Access Compliance Report Public Rights-of-Way (Curb Ramps)

Main Street: WALKER_LEE_DR Cross Street: BELLWOOD_RD Location: SE

ADA ID: RPRK211207134833 Ramp Type: Type 1 - Perpendicular Diagonal Initial Pass/Fail: Pass Overall Compliance: No Severity Score: 10

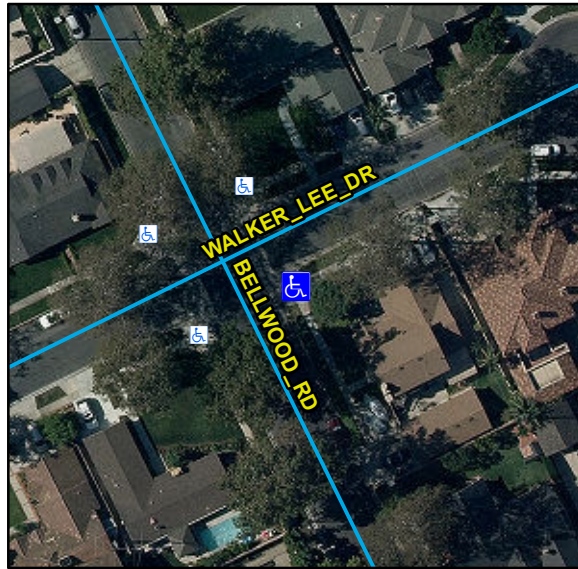
Compliance	Description	Data	Compliance	Description	Data
N/A	Ramp Length (in)	82	N/A	Flare Type LT	
Yes	Ramp Width (in)	48			Sloped
Yes	Ramp Run Slope (%)	6	N/A	Flare Slope LT (%)	3.1
Yes	Ramp Cross Slope (%)	1	N/A	Flare Traversable LT	No
N/A	Landing Present	Yes	N/A	Flare Type RT	
N/A	Landing Length (in)	50			Sloped
Yes	Landing Width (in)	48	N/A	Flare Slope RT (%)	5.4
Yes	Landing Run Slope (%)	1	N/A	Flare Traversable RT	No
Yes	Landing Cross Slope (%)	1.7	No	DWS Provided	No
N/A	Landing Movement Obstructed?	No	N/A	DWS Contrast	N/A
	Landing Movement Type	N/A	N/A	DWS Length (in)	N/A
N/A	Landing Shared	No	N/A	DWS Full Width	N/A
N/A	Clear Space	Yes	N/A	DWS Offset Left (in)	N/A
N/A	Clear Space To Crosswalk (in)	48	N/A	DWS Offset Right (in)	N/A
N/A	Marked Crosswalk 1	No	N/A	Marked Crosswalk 2	No
	Crossing 1 Direction	N		Crossing 2 Direction	W
	Marked Crosswalk 1 Width (in)	N/A		Marked Crosswalk 2 Width (in)	N/A
N/A	Ramp Inside Crosswalk 1	N/A	Yes	Ramp Inside Crosswalk 2	N/A

Crossing 1 Slope (%)	6.1		Crossing 2 Slope (%)	4.4
	Crossing 1 Cross Slope (%)	2.1		Crossing 2 Cross Slope (%)	2.3
Yes	Gutter Ponding	No	Yes	Curb Slope	2.3
No	Gutter Lip Height (in)	0.25		Road Run Slope (%)	1.4
Yes	Gutter Run Slope (%)	1.7		Road Cross Slope (%)	0.1
Yes	Gutter Cross Slope (%)	1.6			
Yes	Overall Surface Condition: Acceptable		No	Perp Joint Present	No
	Cross Gutter Present?	Yes		Spandrel Present?	Yes
	Replace Cross Gutter?	No		Replace Spandrel?	No

Remove & Replace Curb Ramp With Two New Directional Ramps or Equivalent. Grind Gutter Lip.
